APPLICATION NO.	FILING DATE	FIRST NAMED INVENTOR	ATTORNEY DOCKET NO.	CONFIRMATION NO.
10/783,339	02/20/2004	Brian Smidt	10646.399US01 6914	
Merchant & Go	7590 05/17/2007 ould P.C.	EXAMINER		
P.O. Box 2903		PAHNG, JASON Y		
Minneapolis, M	IN 55402-0903		ART UNIT PAPER NUMBER	
		,	3725	
			MAIL DATE	DELIVERY MODE
			05/17/2007	PAPER

DETAILED ACTION

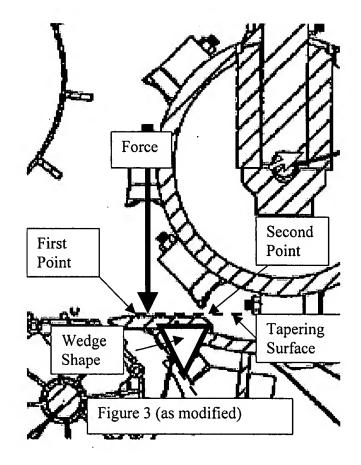
a grinding drum (160) positioned within a mill box (154) having opposite sides
 (155);

- 2. the grinding drum (160) having an axis of rotation (axis of 171);
- 3. an anvil (182) having a cross-section, the cross-section including a wedgeshaped portion and a rectangular portion (Figure 3);
- the wedge-shaped (182) portion having a tapering surface extending from a first reference point (closest to 171) to a second reference point (farthest from 171);
- 5. the ends of the anvil (182) extending beyond (Figure 5a) the sides (155) of the mill box (154); and
- 6. the first and second reference points are horizontally aligned with one another.

With regard to claims 13, 28, 34, and 37, Verhoef discloses an anvil (182) of solid construction (Figure 3) without weakening structure. The top tapering surface of the wedge portion is oriented perpendicular to vertical impact perpendicular forces generated by the grinding drum as shown above in Figure 3 (as modified). In fact, Verhoef's discloses generated force as shown in Applicant's Figure 3.

Verhoef discloses a horizontal tapering surface as shown below in a modified Figure 3.

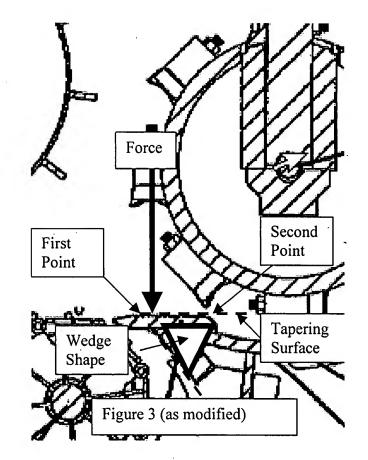
With regard to claims 12, 13, 15-17, 28, 31-35, and 37, Applicant argues that Verhoef does not disclose a horizontal tapering surface. This is not persuasive.

With regard to claims 12, 13, 15-17, 28, 31-35, and 37, Applicant also argues that Verhoef does not disclose an anvil including a wedge shaped portion. This is also not persuasive. Verhoef discloses an anvil including a wedge shaped portion as shown above in a modified Figure 3. Also, it is pointed out that Applicant does not disclose an exact wedge shaped portion. See Applicant's Figure 9. Applicant merely discloses a portion similar to a wedge-shaped portion.
